CONDITION OF CONCERN

On the subject Mazda2 vehicles, the headlight adjustment prevention cap was not installed during the manufacturing process, which may allow the headlight horizontal aiming to be improperly adjusted by end users. The vehicles with missing headlight adjustment prevention caps do not conform with Federal Motor Vehicle Safety Standards (FMVSS) regarding vehicle headlight adjustability.

OUTLINE OF REPAIR

Backside of Headlight

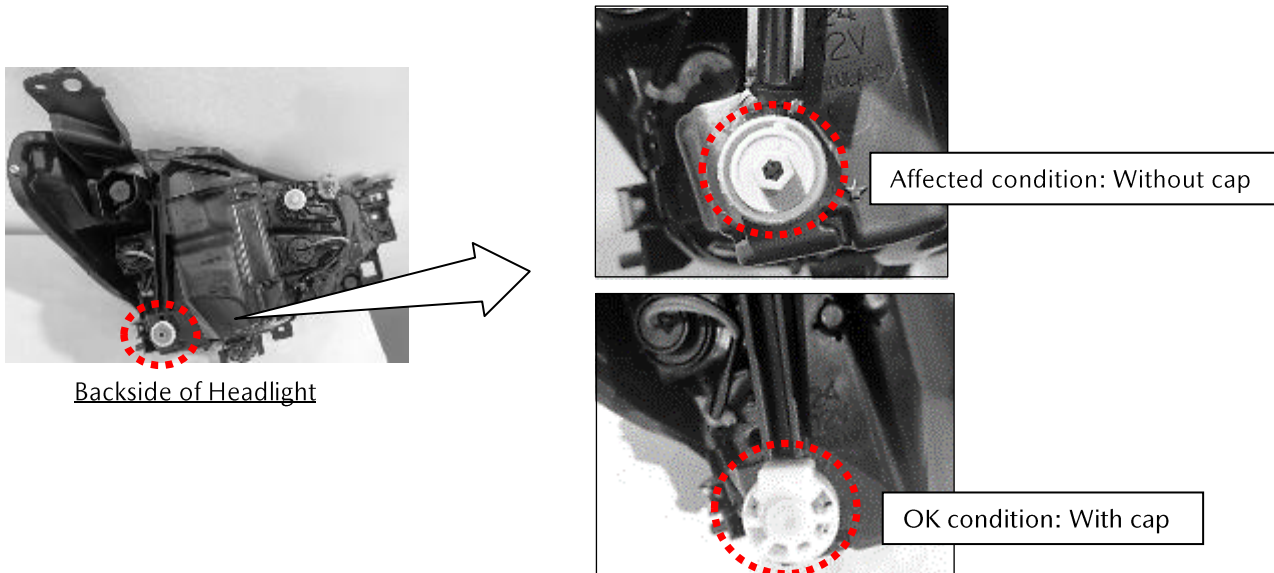
- Applicable FMVSS: FMVSS No. 108, "Lamps, Reflective Devices and Associated Equipment"

Install a headlight adjustment prevention cap on each front headlight (right and left).
 Please refer to the Repair Procedure document on MGSS for further details.
